# CITY OF PORTLAND, MAINE

## HISTORIC PRESERVATION BOARD

**TO:** Chair Sheridan and Members of the Historic Preservation Board  
**FROM:** Deb Andrews, Historic Preservation Program Manager  
**DATE:** January 9, 2019  
**RE:** January 16, 2019    **2<sup>nd</sup> WORKSHOP – Preliminary Review of Proposed Hotel Construction**

**Address:** One Center Street  
(northeast corner of Commercial and Center)

BUILDING TWELVE LOOKING FROM EAST & NORTH:

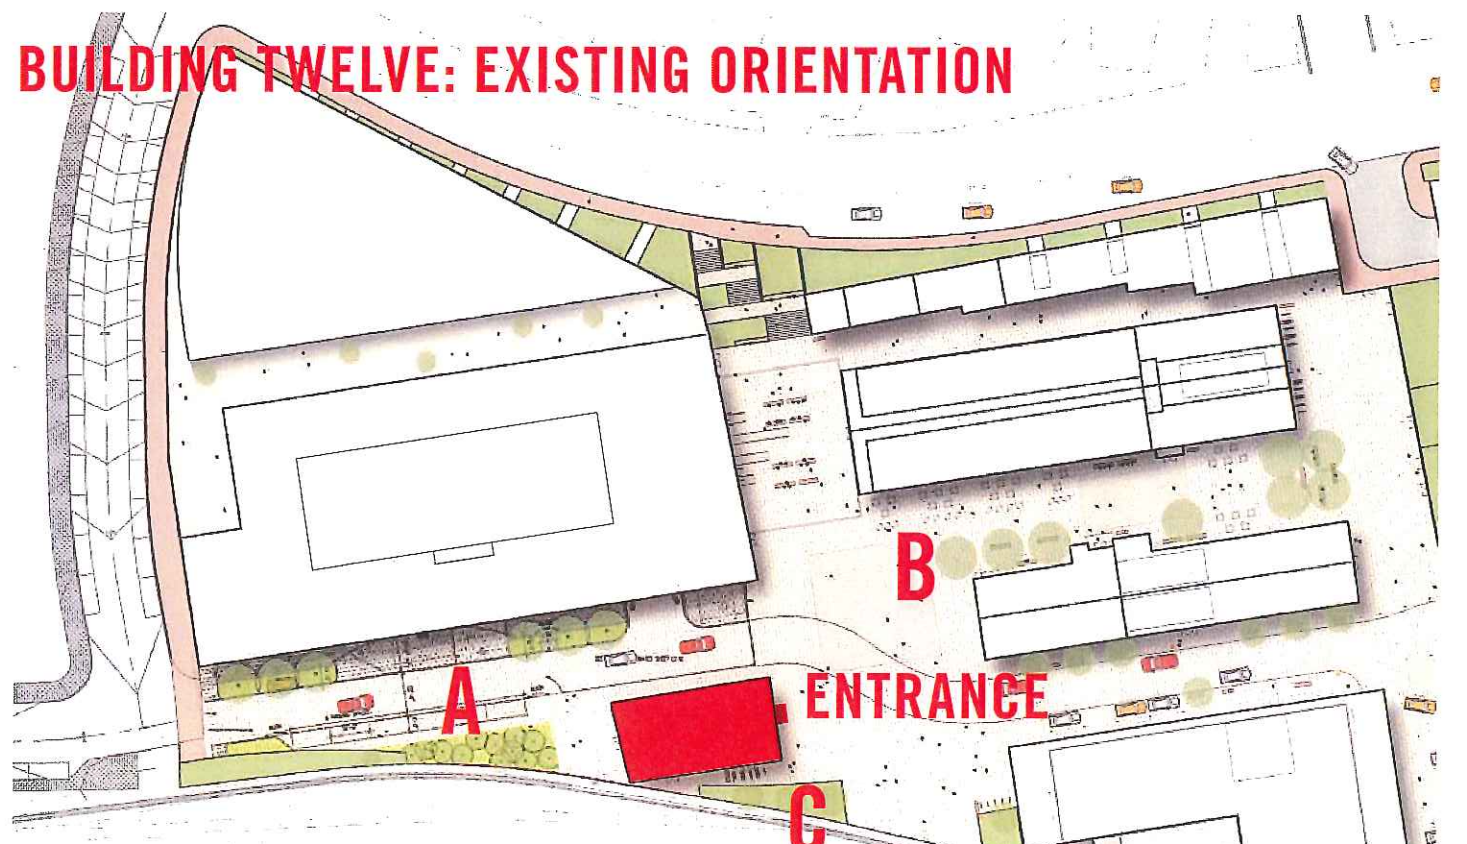
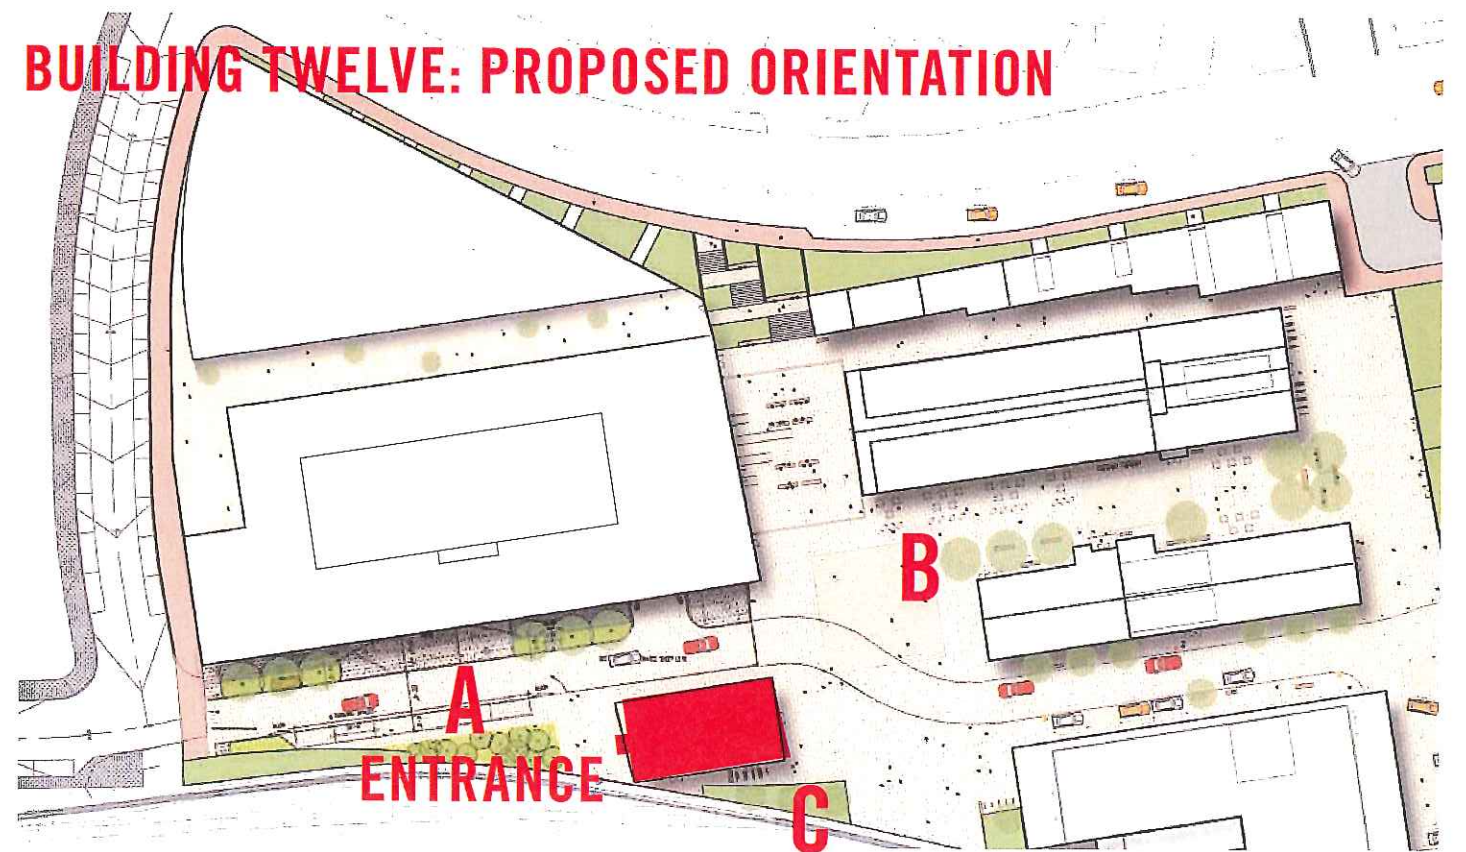
Finally, the renderings indicate that continuous dormers are proposed for both the south and north roof planes.
